DEVELOPMENT REVIEW COORDINATOR
POST APPROVAL PROJECT CHECKLIST

Project Name: Seaport Lofts (Bay House Phase II)

Site Plan ID Number: 2013-179

Project Name: Seaport Lofts (Bay House Phase II)
Address: 101-121 Newbury St./40 Hancock St.
Applicant: 113 Newbury Street, LLC

Monitoring Points on New Retaining Wall

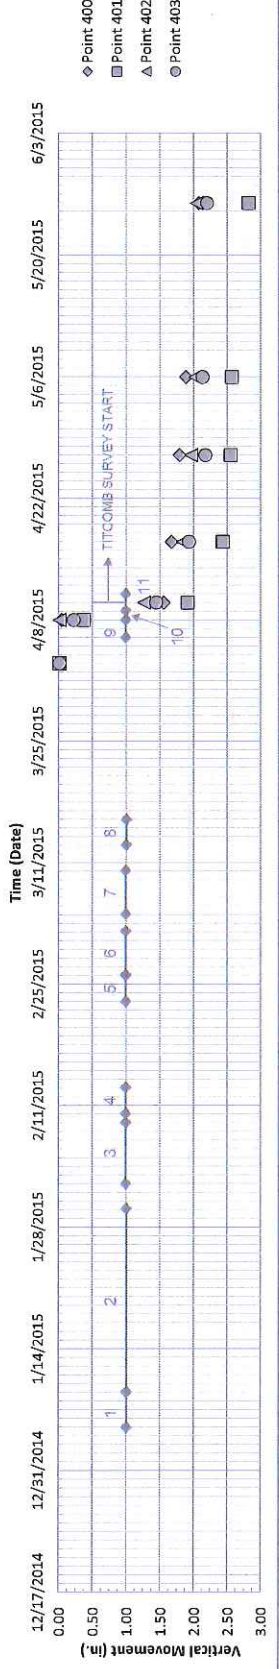
- Extraction of sheeting on 9 and 10 April (event No. 11) precipitated approximately 2 in. of settlement of the new retaining wall (see Figure 3, Appendix B). Based on discussions with the adjacent property owners, it appears that extraction of the sheeting also precipitated the foundation settlement and cracking of the foundation walls and floor slab at 48 Hancock Street (blue building), settlement of the backyard patio at 36 Federal Street (white house) and the surficial tension crack that was observed at ground surface behind the 38, 40, 42 and 44 Federal Street townhouses. Please note that the owner of 40 Federal Street stated that the tension crack was not present in the back of the townhouses on the morning of 9 April but was present around noontime on 9 April after the start of sheeting extraction had begun.

Figure 1

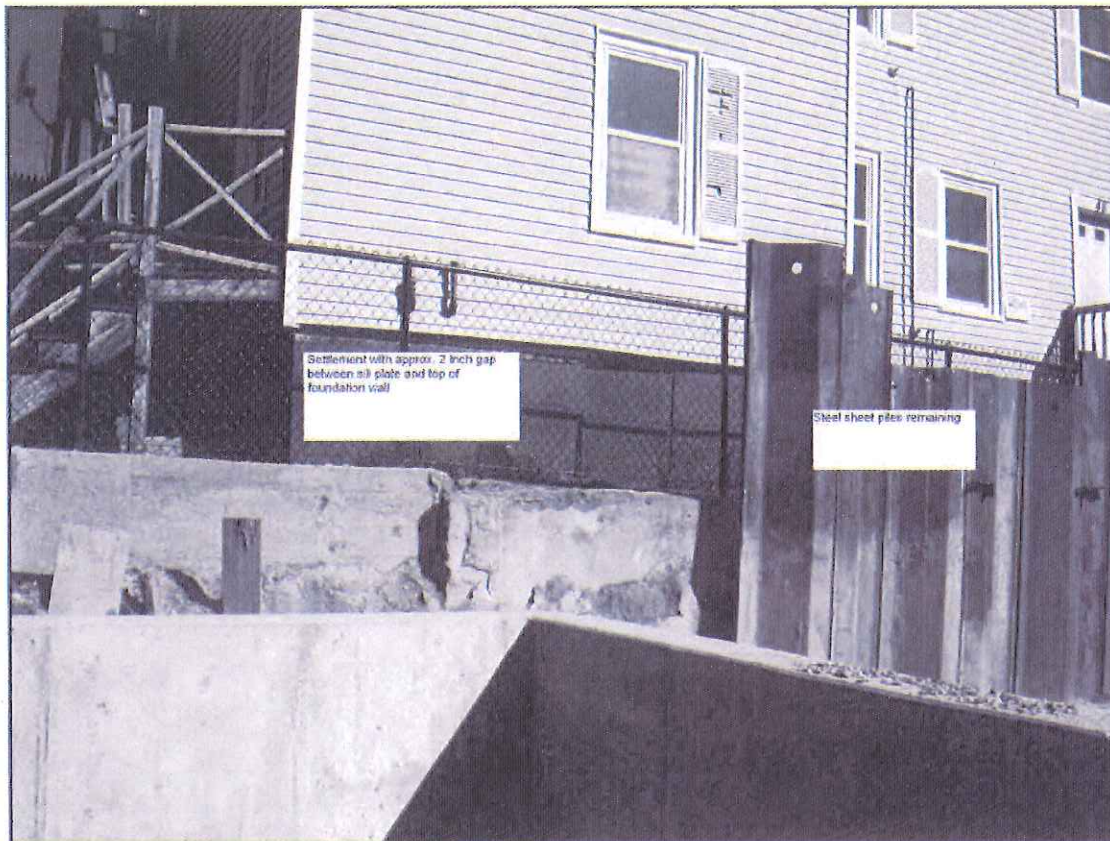
During and following and extraction of steel sheet piles, foundation settlement occurred at the corner of an adjacent structure on Hancock Street. This is depicted on Figure 1.

The foundation settlement is most apparent along the length of sheet pile removal. It is believed that the existing foundation occurs within the influence of the SOE. As such, the SOE design would have to be inherently stiff and the removal of SOE elements may pose risk of disturbance to existing structures.

Figure 2

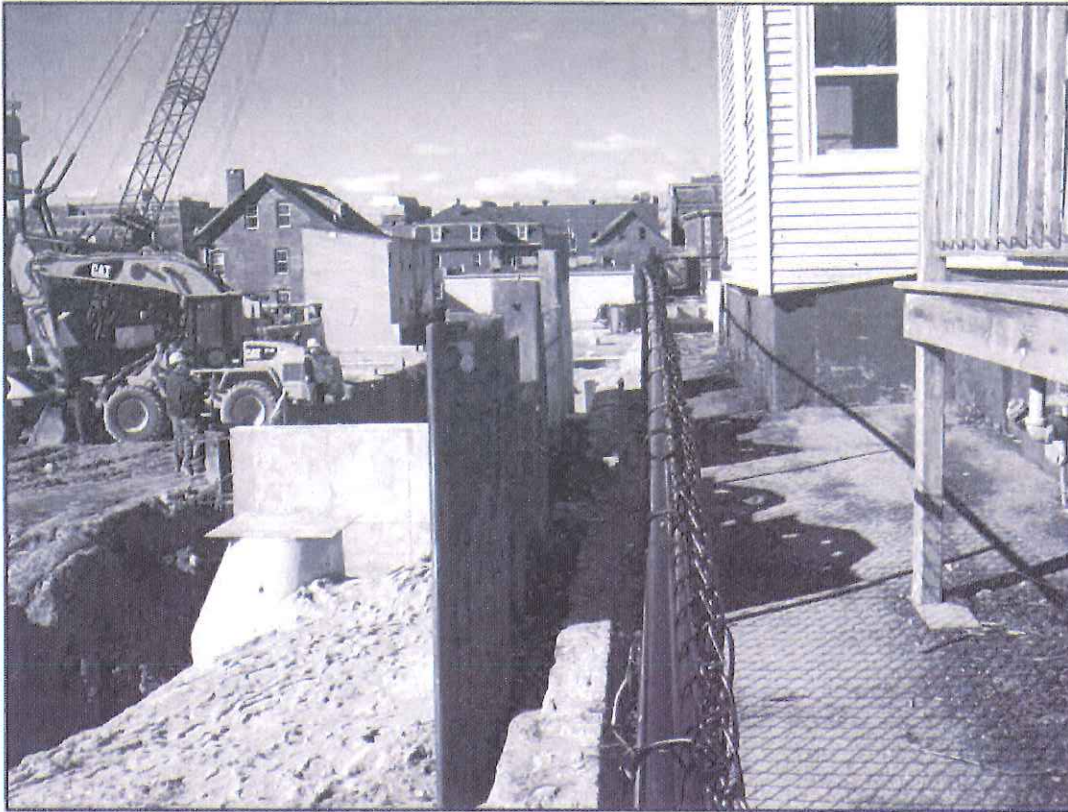
Figure 2 illustrates the proximity of the structure to the SOE system.

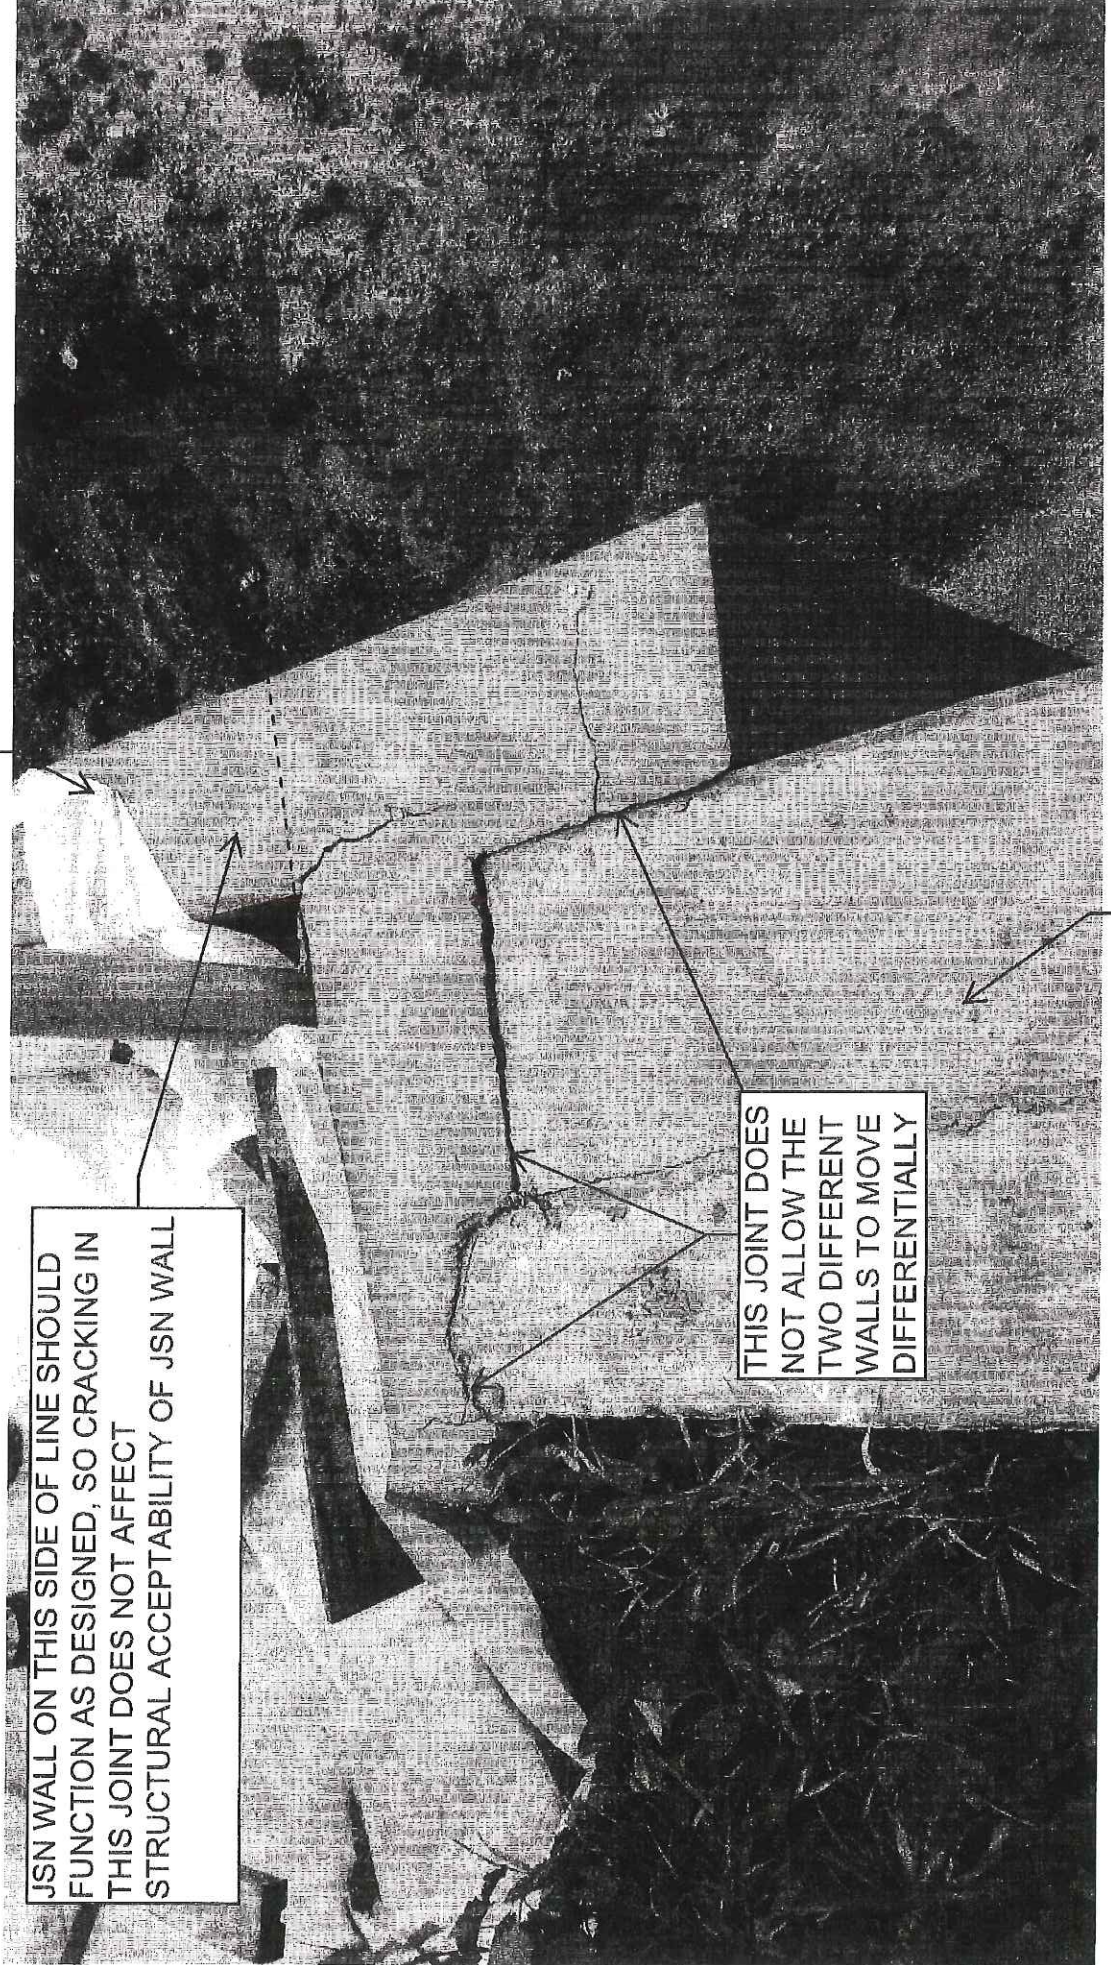
TOP OF THE JSN DESIGNED
WALL WAS RAISED TO THIS
ELEVATION TO MATCH A SITE
WALL BY OTHERS - SITE WALL
BY OTHERS STARTS
APPROXIMATELY 18'-9" FROM
THIS STEP
- GRADE BEHIND JSN DESIGNED
WALL TO BE AT 6"± BELOW
DESIGNED TOP OF WALL
ELEVATION

WALL HAS TIGHT
DIAGONAL CRACKS
THAT DO NOT APPEAR
TO BE GETTING WIDER
AT THIS TIME - G.C.
NOTED THAT SOME
CRACKS HAVE GOTTEN
LONGER, BUT ARE
STILL TIGHT

THIS CURRENT GRADE ON THE TOE-SIDE OF THE
WALL APPEARS TO BE 9"± BELOW THE FINISHED
GRADE AS SHOWN IN THE STRUCTURAL DRAWINGS
- CONSTRUCTION PHASING DOES NOT ALLOW THE
FINISHED GRADE TO BE BROUGHT UP AT THIS TIME

JOIN DESIGNED WALL (WITH
EXTENSION BY OTHERS TO
RAISE TOP OF WALL TO MATCH
AT THIS JOINT)
